**Re: Request for Access to Information Under Part II
of the Access to Information and Protection Privacy Act**

Project: Glencrest-Galway Development – Application for Re-zoning
Project No.: PN 10003

Re: Glencrest/Galway – Response to Staff Comments

Parkland
&
Pedestrian
Trail Plan

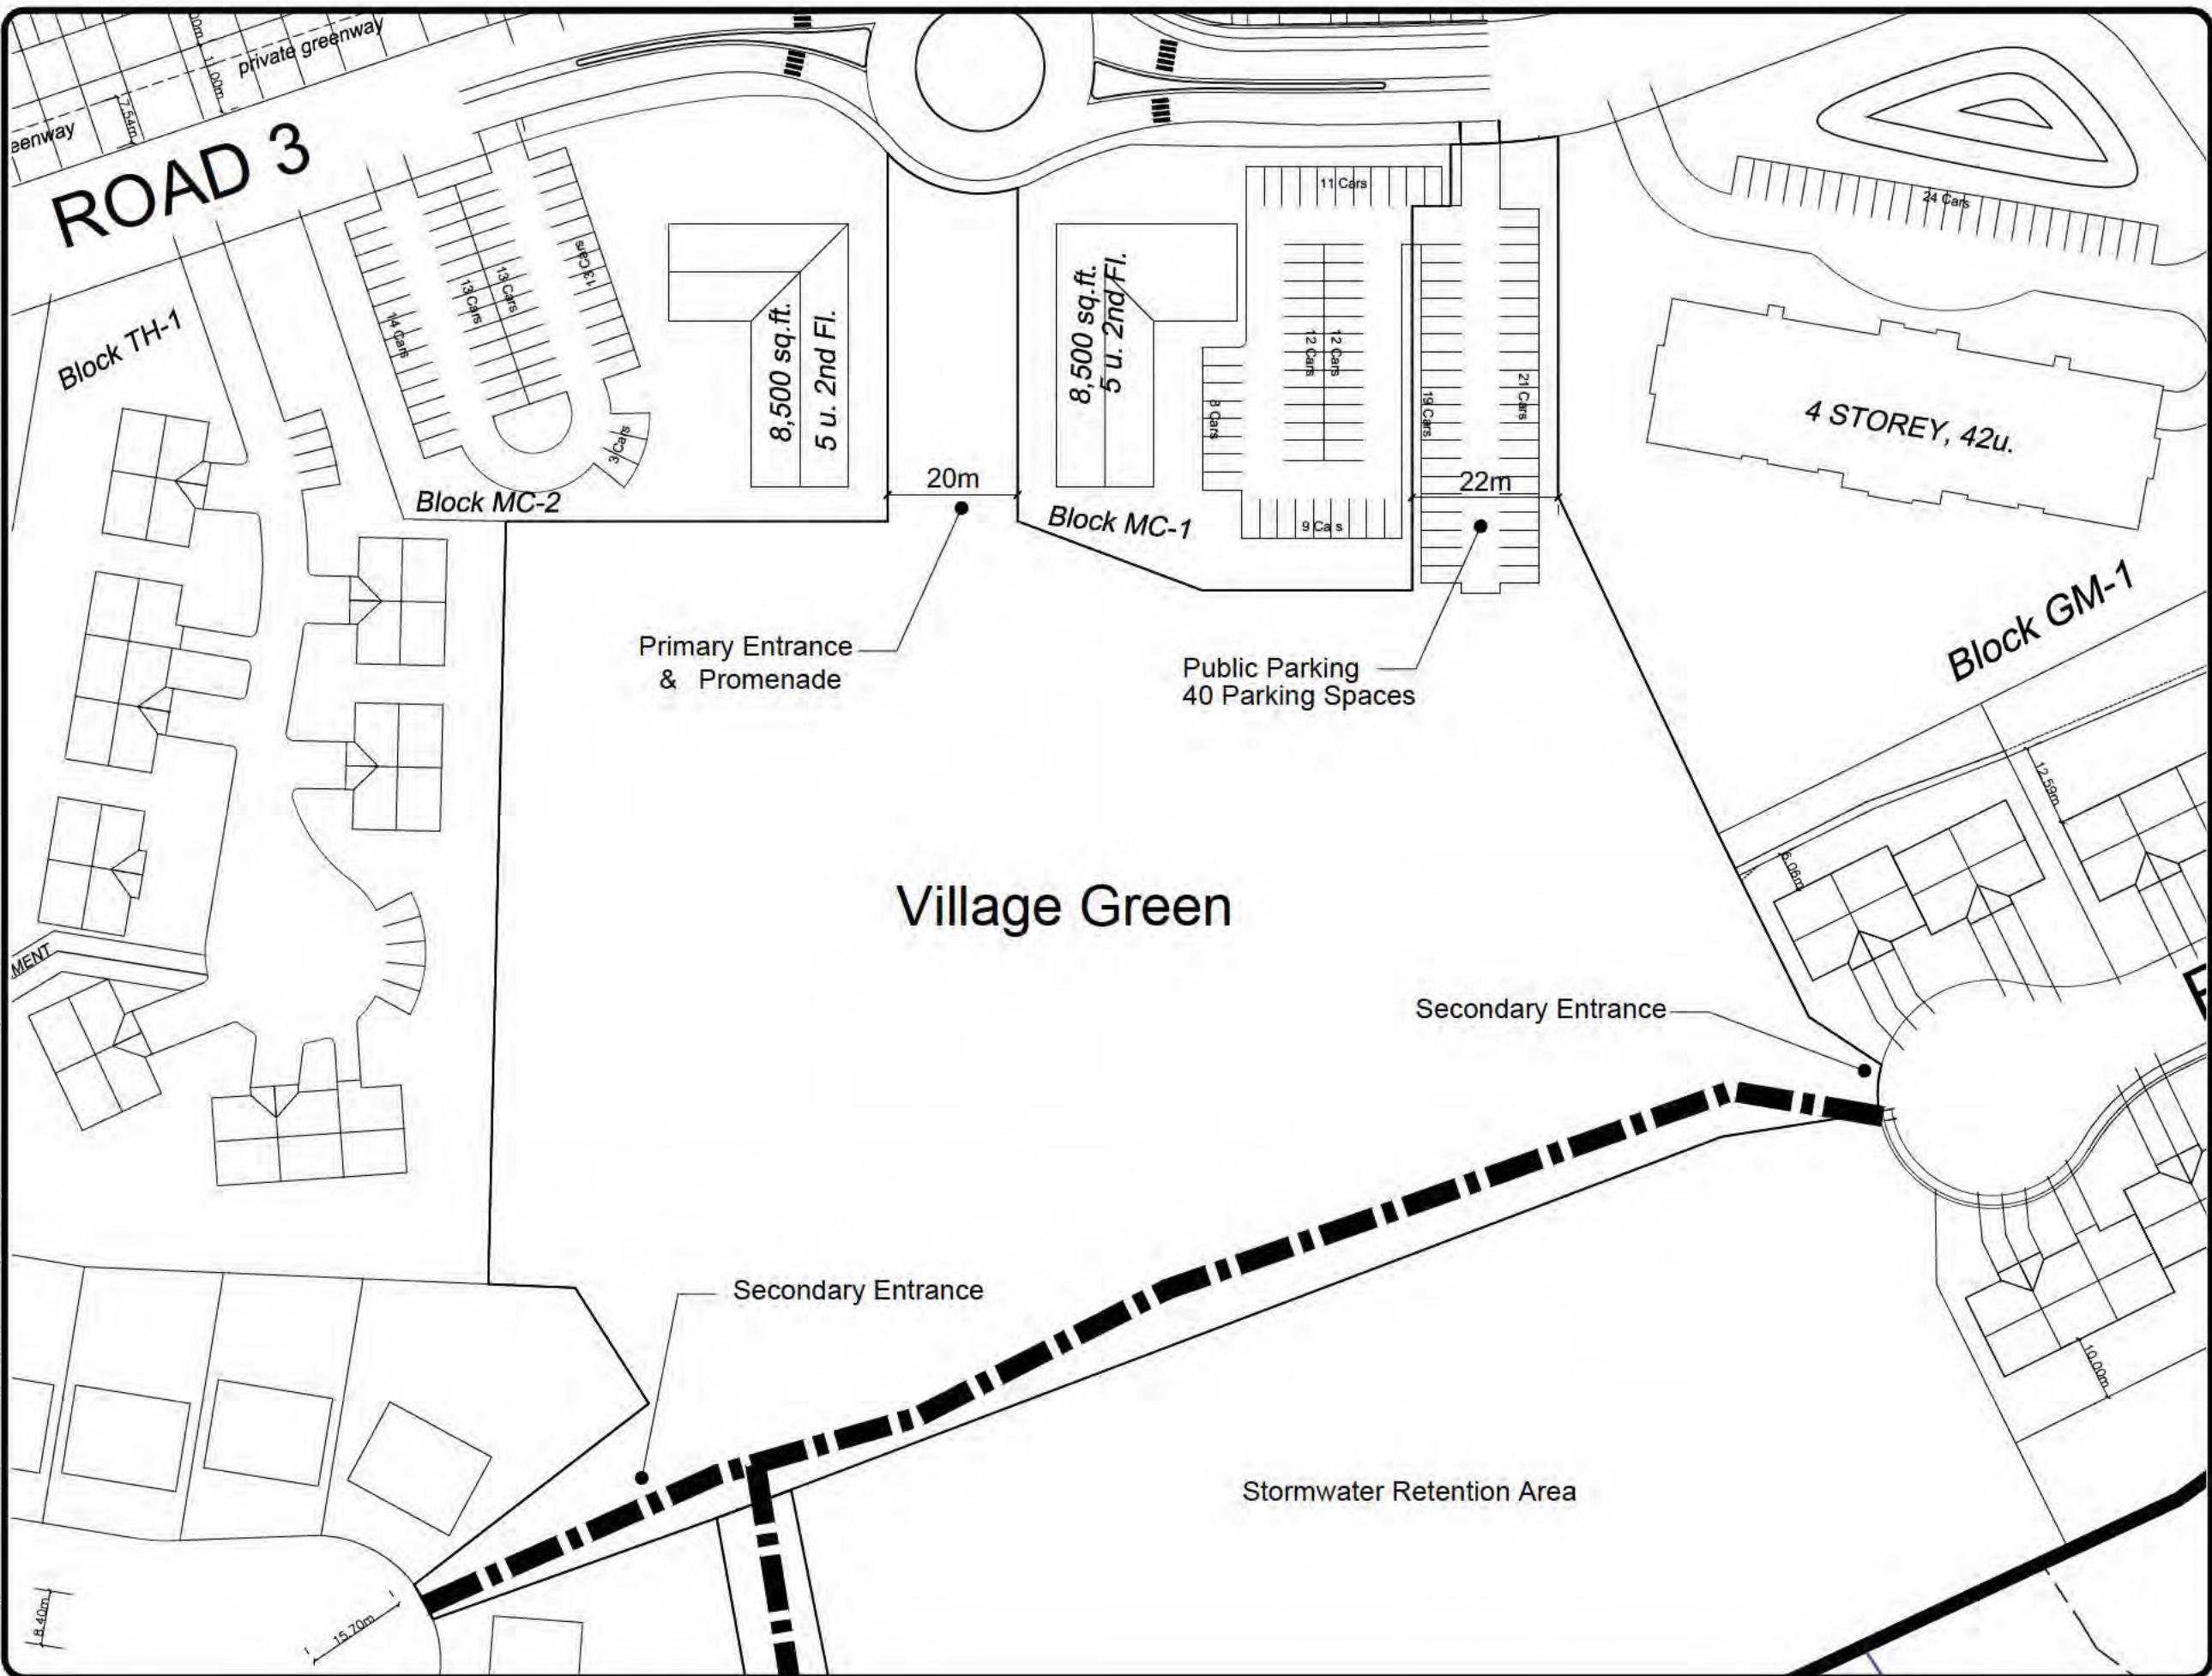
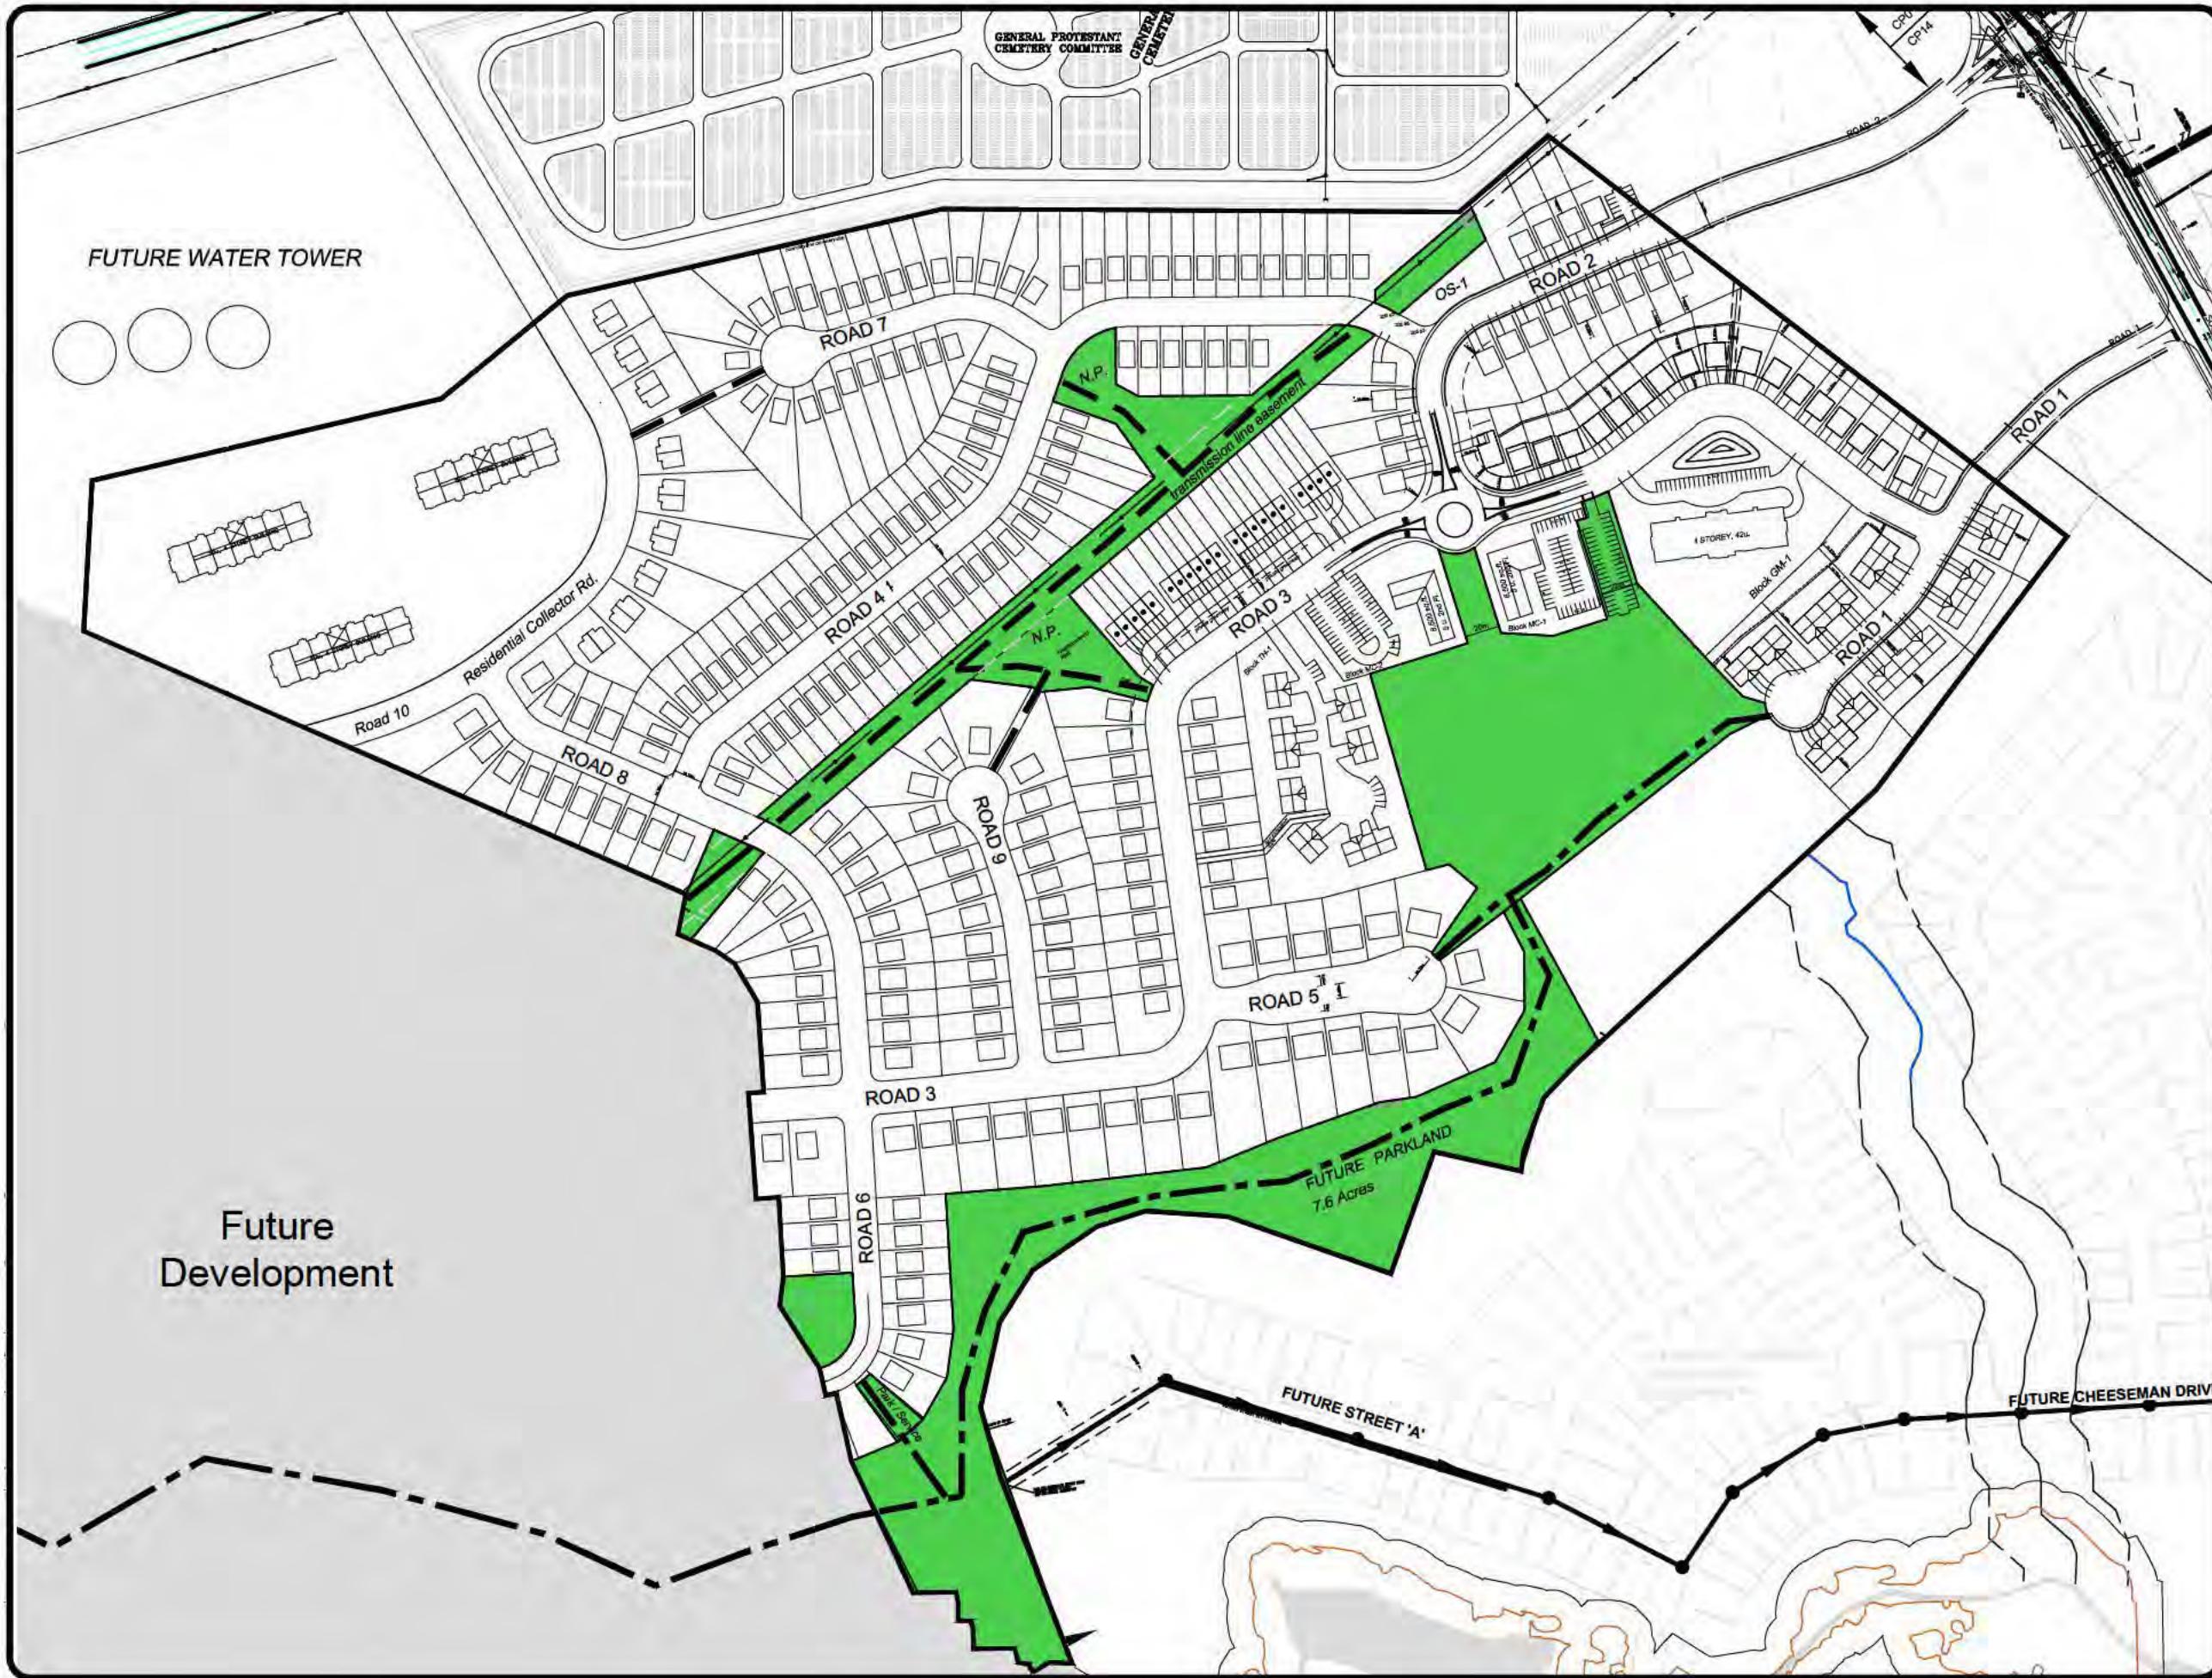
7. A sidewalk (or multi use trail) should be placed on both sides of all cross sections. In limited cases, adjustments to this requirement may be entertained as long as the overall goal of maintaining safe access for all modes of transport between homes and destination within and outside the community is maintained. The developer should revised cross sections accordingly. Details of any variations should be provided for review. **We disagree. This is a significant extra cost that, in our opinion, is not needed for safety. We can review multiple other jurisdictions as examples. It should also be noted that the proposed investment in off-street walking and cycling trails is unmatched elsewhere in the City and is required to achieve the envisioned plan. If the above noted City comment were to be implemented it would necessitate a reduction in the off-street walking and cycling trails and would detract from the master planned community. We welcome further discussion on this matter.**

12. Details of the proposed neighborhood parks should be provided and should be consistent with the Parks and Open Spaces Master Plan. **Further consultation required with city staff, but not an issue we foresee critical to the rezoning.**

We have included a revised sidewalk and trails plan for your consideration. There are three streets which will include sidewalks on each side. Road #2 will be the main entrance to the community and is proposed to have sidewalks on both sides of two travel ways separated by a

You will note a series of trails identified on the “Pedestrian Movement” plan. Trails marked in green are intended to be 5 - 6ft wide crusher-dust trails for the exclusive use of pedestrians. Trails marked in orange are intended for both pedestrians and cyclists. Our intention is to work with staff during the detail design/permitting phase to better understand the partnership opportunities for maximizing end user experience of these trails. We have attempted to follow the thinking contained in the December, 2014 Park and Open Space plan, but would appreciate a more thorough discussion with staff in parallel with the rezoning process.

The smaller neighborhood parks require additional commentary from staff. Again, this may not be necessary for the proposed rezoning. We have attempted to integrate these areas with the pedestrian trails in a manner that reflects the intent of the city’s Open Space Plan. However, we are flexible and open to suggestions as to the location and intended use of these areas.
